HISTORIC AND DESIGN REVIEW COMMISSION

HDRC CASE NO: 2015-109
ADDRESS: 1115 S ST MARYS
LEGAL DESCRIPTION: NCB 2963 BLK 11 LOT S 95 FT OF A19
ZONING: C2 H HS
CITY COUNCIL DIST.: 1
DISTRICT: King William Historic District
LANDMARK: House
APPLICANT: Arturo Rivera
OWNER: Roberto Medrano
TYPE OF WORK: Construction of a semi-circular driveway and fence replacement
REQUEST:

The applicant is requesting a Certificate of Appropriateness for approval to:

Proposal

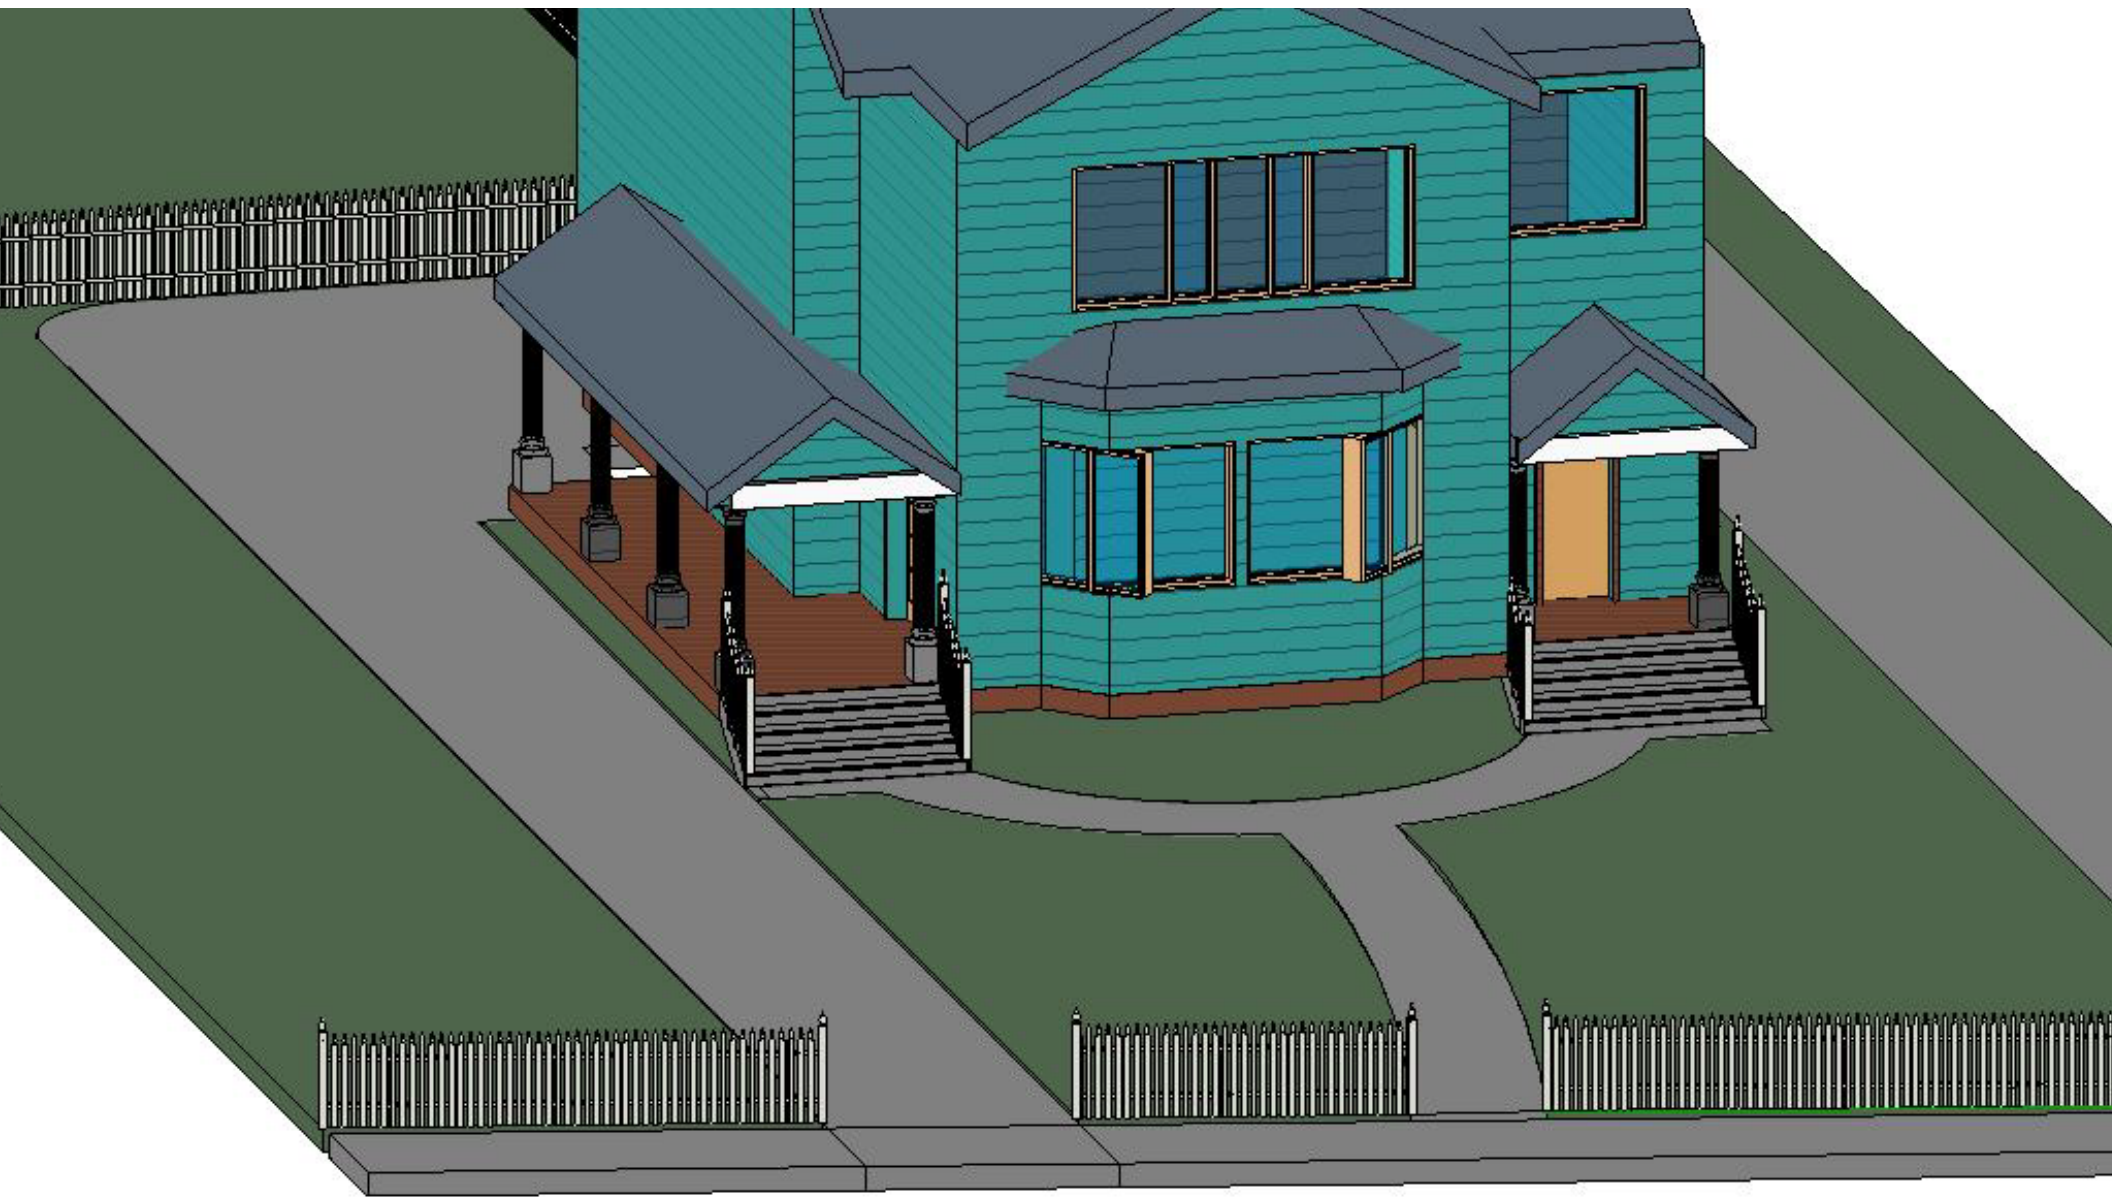
- c. The applicant has proposed to construct a driveway of crushed granite that is to extend from the existing rear parking lot to the front yard where an additional curb cut will be needed for access to S St Mary's. The applicant has proposed for the new curb cut to be ten (10) feet in width to match the existing. The Guidelines for Site Elements 5.B.i. states that historic driveways are typically no wider than 10 feet and that a similar driveway configuration regarding materials, width and design should be used that would be historically found on the site. The applicant has proposed a paving system of crushed granite for the proposed driveway. The applicant's proposal for an additional driveway is consistent with the Guidelines for Site Elements. Staff's recommendation for approval of the proposed driveway as well as curb cut is in regards to the historic context of the property, not zoning. The applicant is responsible for complying with all zoning regulations regarding the proposed additional curb cut.

- d. Along the front (east) of the property at the side walk and along the drive way on the north side, there is an existing wrought iron fence. The applicant has proposed to remove this existing wrought iron fence and to install a new, white picket fence along the east and north sides to match the existing white picket fence that exists on the south side of the property. This request is consistent with the Guidelines for Site Elements 2.B.

- e. The applicant has noted that entrance and exit signage is to be installed with the proposed circular driveway, but has not specified the design of these signs nor the location. The applicant should provide staff with more information regarding the proposed signage to ensure that it is consistent with the Guidelines for Signage.

Staff recommends approval of items #1 through #3 based on findings a through e with the following stipulations:

- i. That the applicant provide staff and the HDRC with more information regarding the proposed signage.
- ii. That the proposed white picket fence is no taller than four (4) feet tall at any location.
